SERVICE BULLETIN

SERVICE BULLETIN INDEX

FIGURE 1: VIEW LOOKING INBD., L/H PYLON

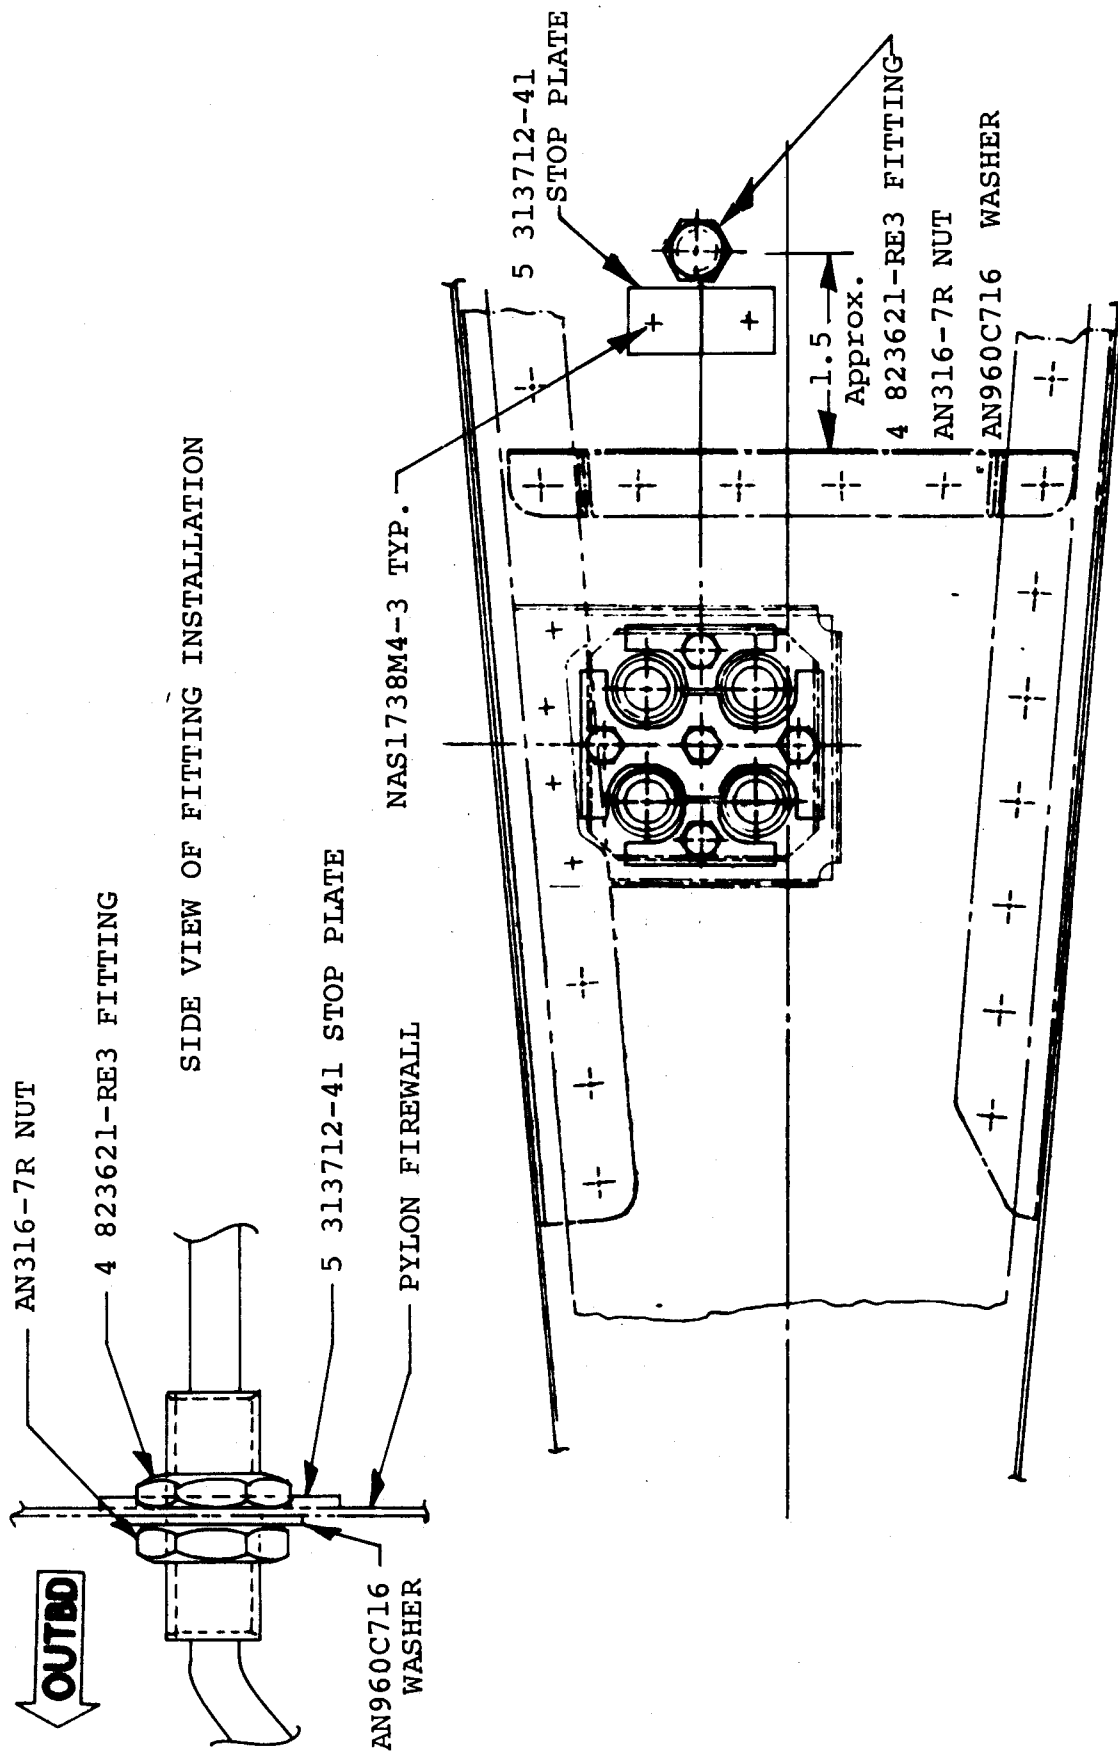
- A. Remove electrical power from the aircraft.
- B. Remove the forward-most access panel on the bottom of the right hand pylon fairing. Remove upper engine cowling.
- C. Drill a 15/32 in. hole through the pylon skin and install one each P/N 4 823621-RE3 fitting, AN960C716 washer, AN316-7R nut, 5 313712-41 stop-plate, per Figure 1. Avoid damaging generator leads.
- D. Disconnect wires 2P16B16 and 2P17B16 from right hand starter/generator terminals A and D. Cap and stow.

FIGURE 1

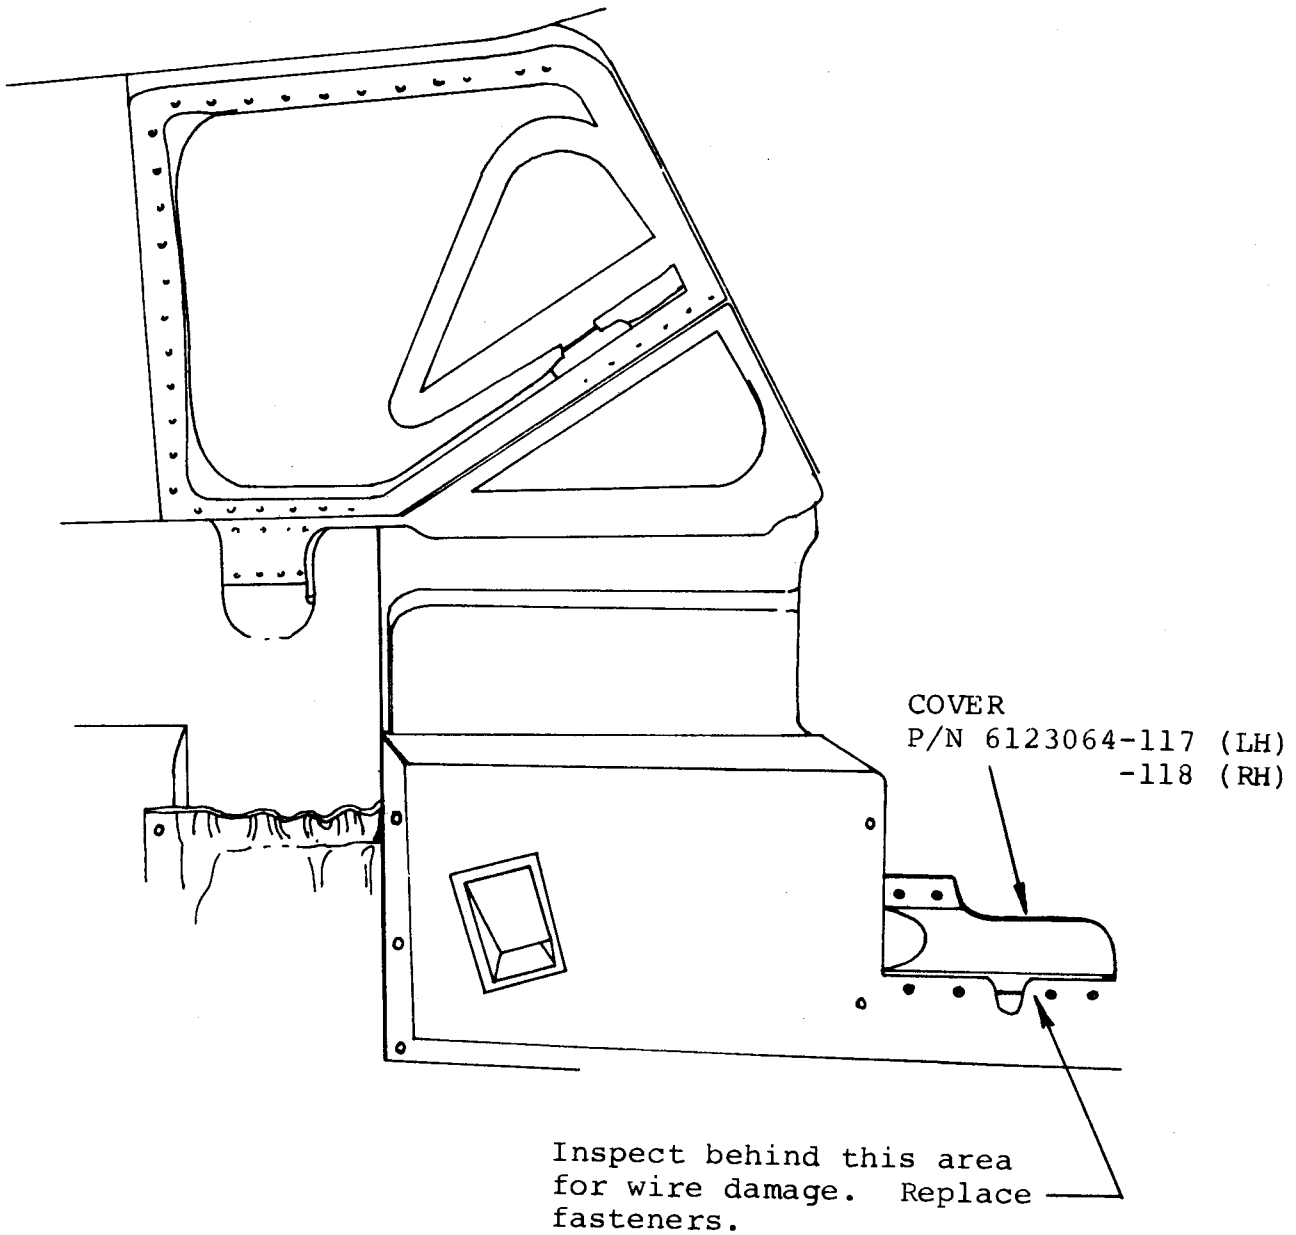
- A. Turn off battery and electrical master switches and assure that external power is not applied to the aircraft.
- B. Remove the lower forward left and right hand panels. See Figure 1.
- C. Inspect the cable bundles in the area immediately behind the lower forward mounting screw on both LH and RH covers for wire damage. Should damage or chafing be noted, repair wires as necessary.

- D. To prevent further damage, wrap the affected area with PVC-80 or equivalent chafe-guard and secure with tie-wraps.
- E. Remove the existing tinnerman type nut-plates from the lower forward positions on each cover and replace them with new nut-plates NAS1474A08. The new nut-plates may be located and riveted in place with MS20426AD3-4 rivets.
- F. Reinstall the left and right covers using washer NAS391-8P and screw MS24693-S48.

FIGURE 1

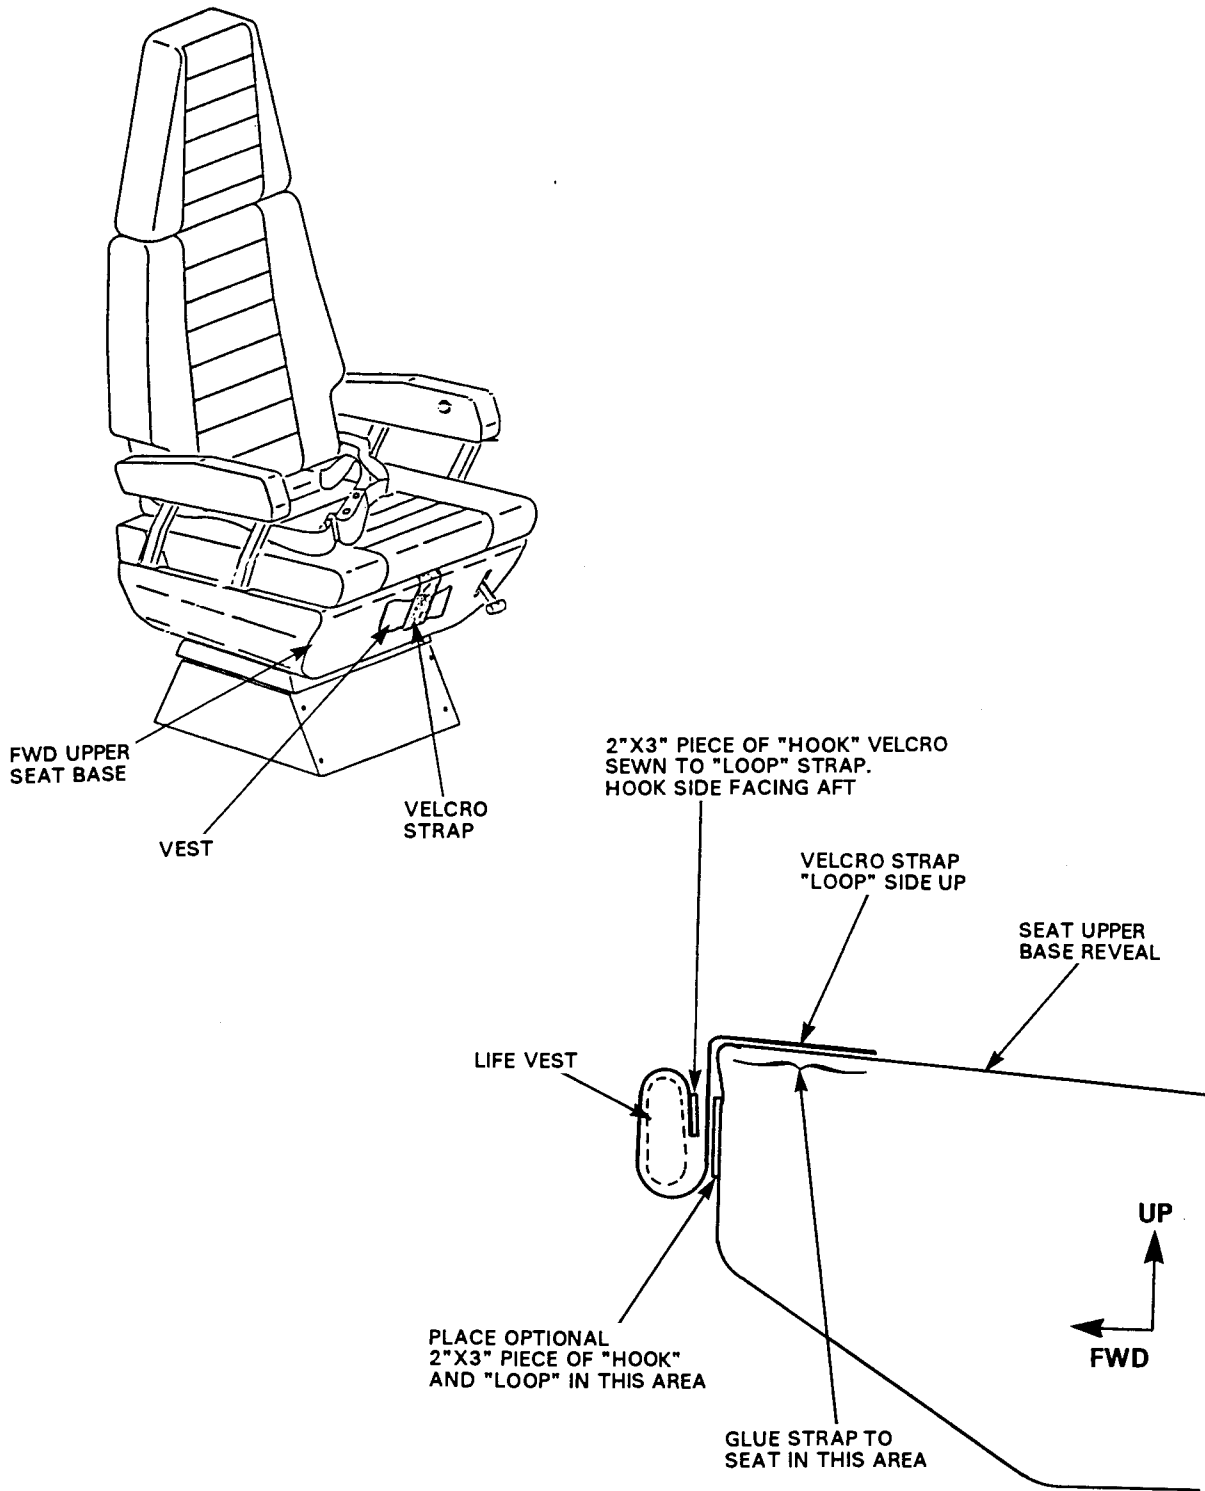
- E. Place life vest with strap assembly in front of seat cushion upper base and allow life vest to hang from velcro strap. Refer to Figure 1.
- F. When desired location is achieved, cut velcro "Loop" strap to appropriate length.

- G. Secure backing side of "Loop" strap to seat cushion support with 3M Scotch Grip P/N 3M 1300L. Refer to Figure 1.
- H. Perform same installation sequence with remaining cabin seats.

FIGURE 1

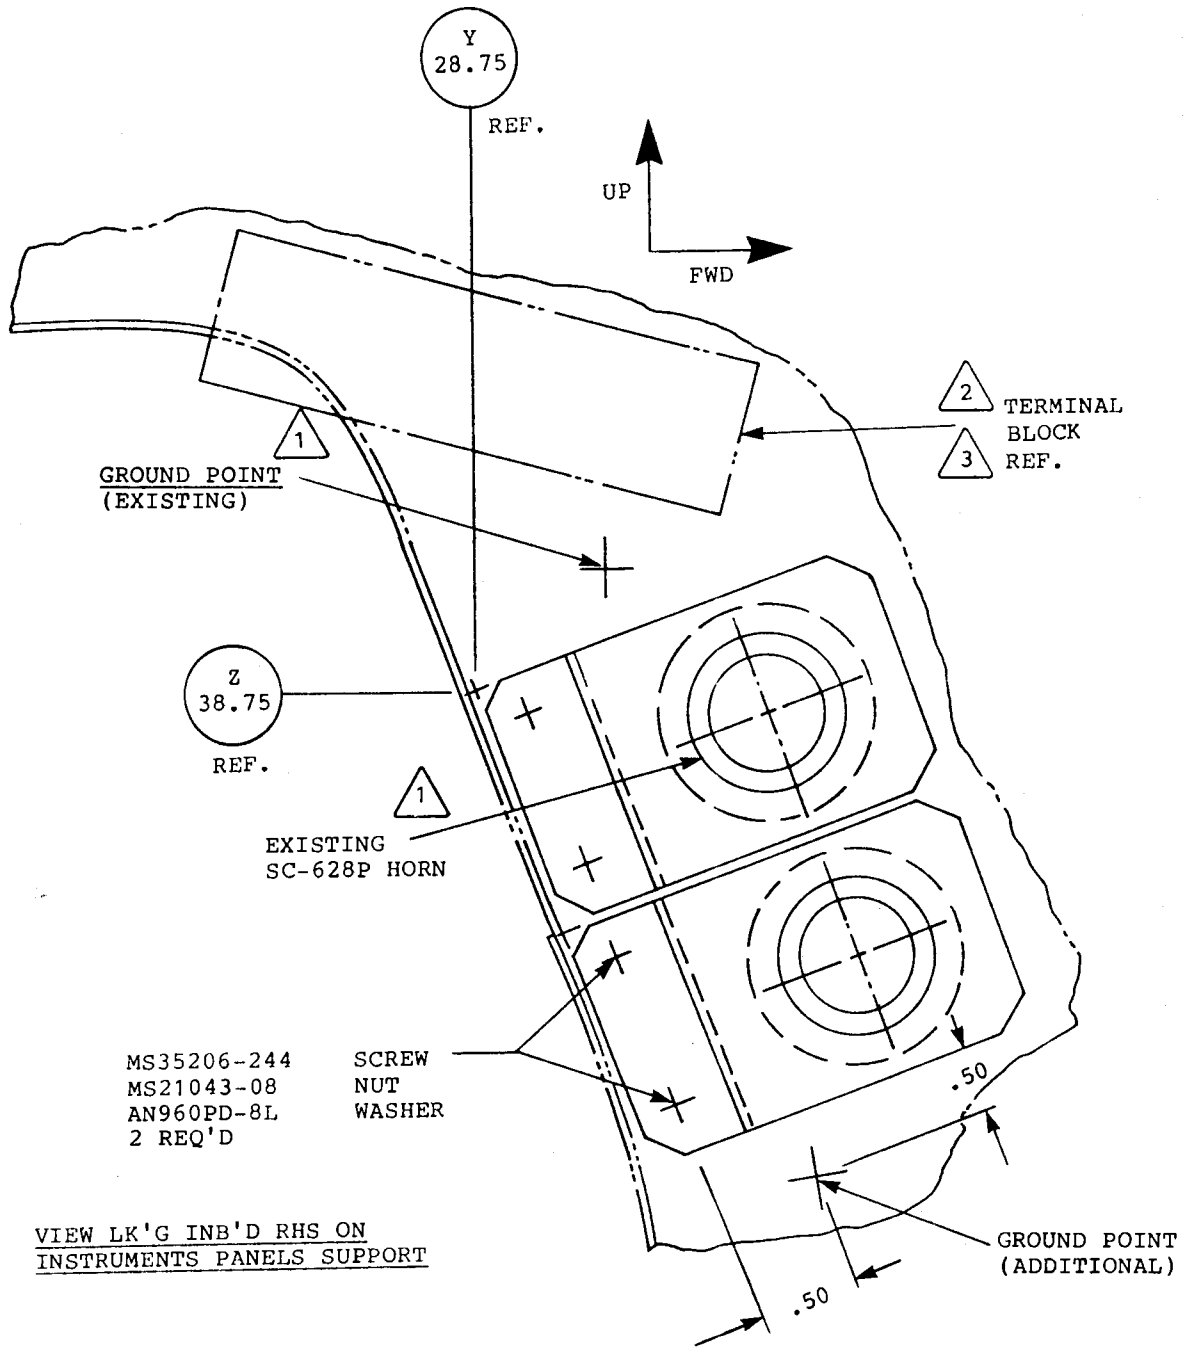
- (8) Locate terminal board on outboard side of right hand instrument panel support assembly. (Reference Figure 1 for location.)
- (9) Locate plugs J49 and J18 on shelf aft of forward pressure bulkhead.

- (1) Locate and mount two (2) Zee brackets (P/N 101-722-50-56) on the center instrument panel support assembly (copilot side). Reference Figure 1 for location and mounting.

FIGURE 2

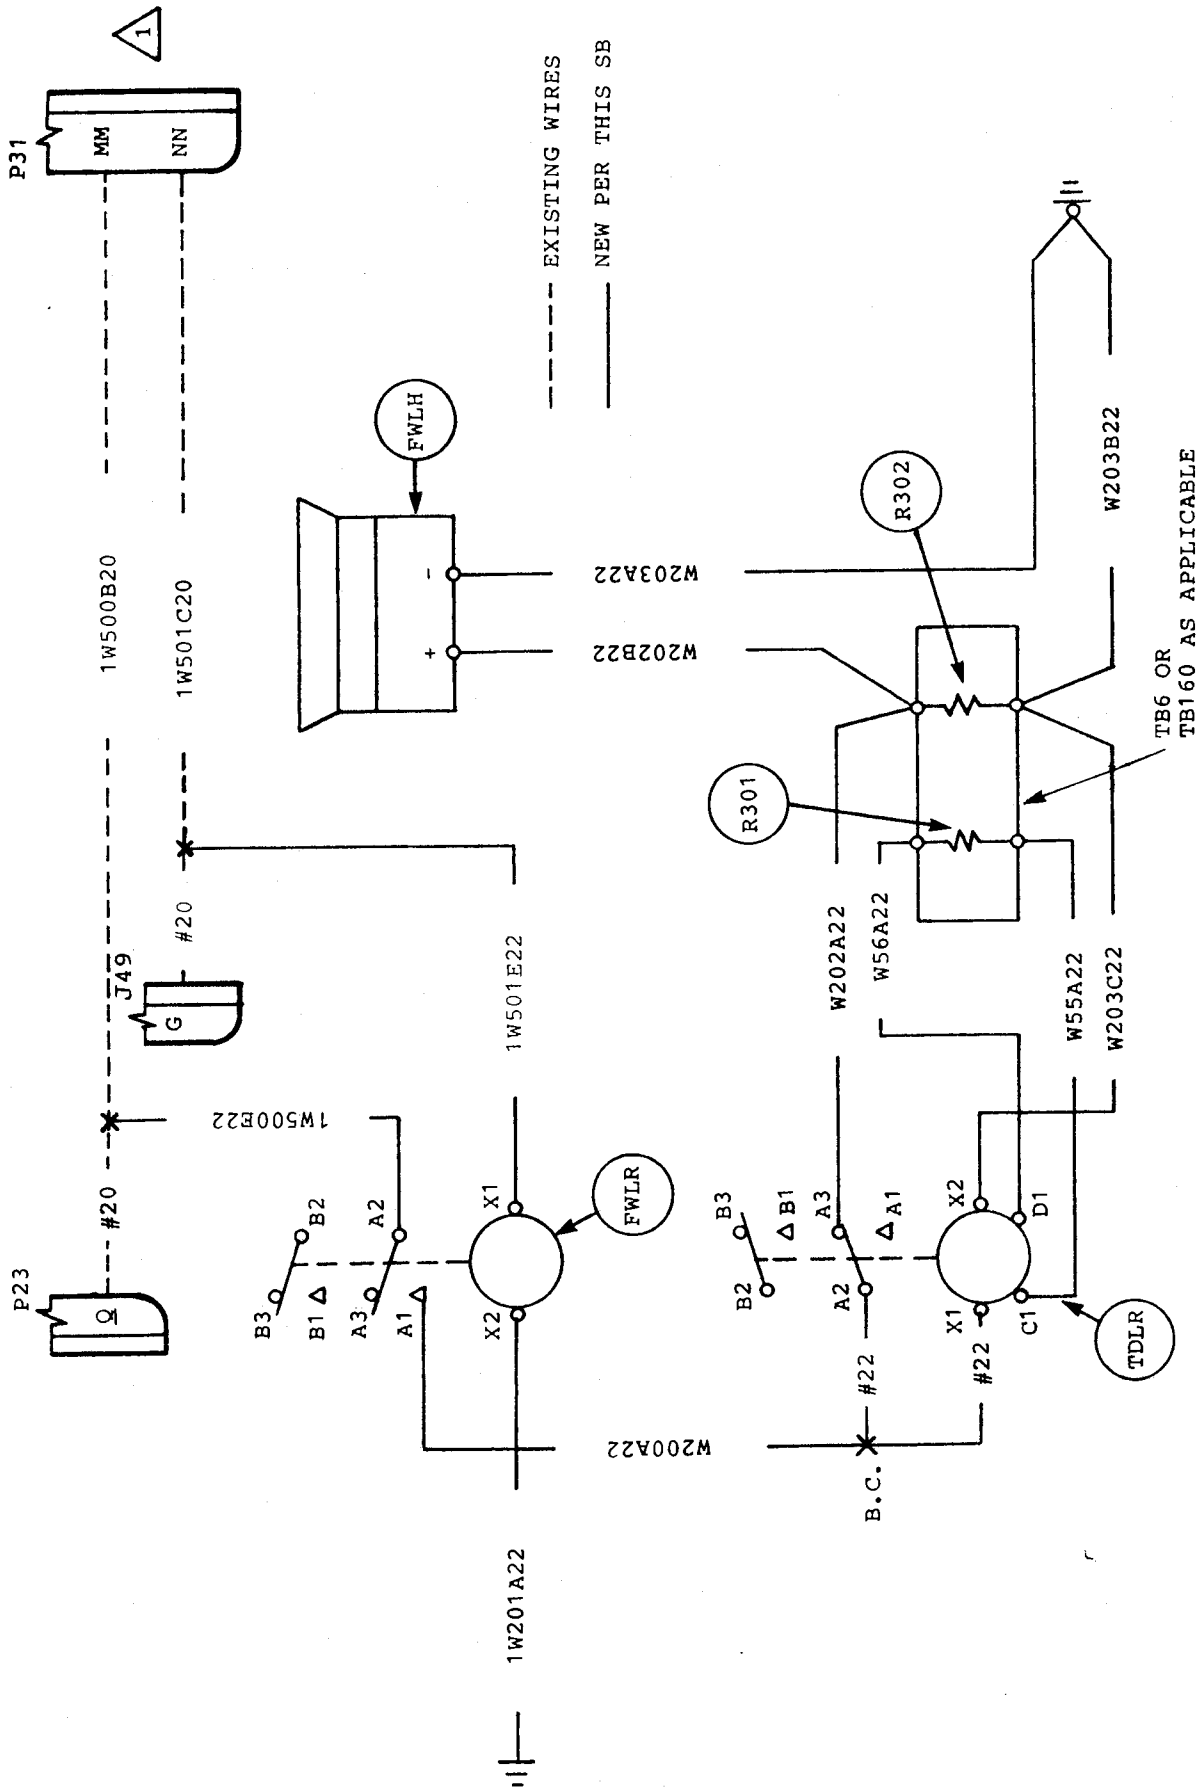
- (1) Complete all wiring as per Figures 2 and 3 (LHS and RHS, respectively), using standard shop practices.
 - (a) Plugs J49 and J18 are located on shelf aft of forward pressure bulkhead.
 - (b) Plugs P23 and P24 are located in the overhead panel (LHS and RHS, respectively).
 - (c) The terminal block is located and identified as per Figure 1 on the instrument panel support.
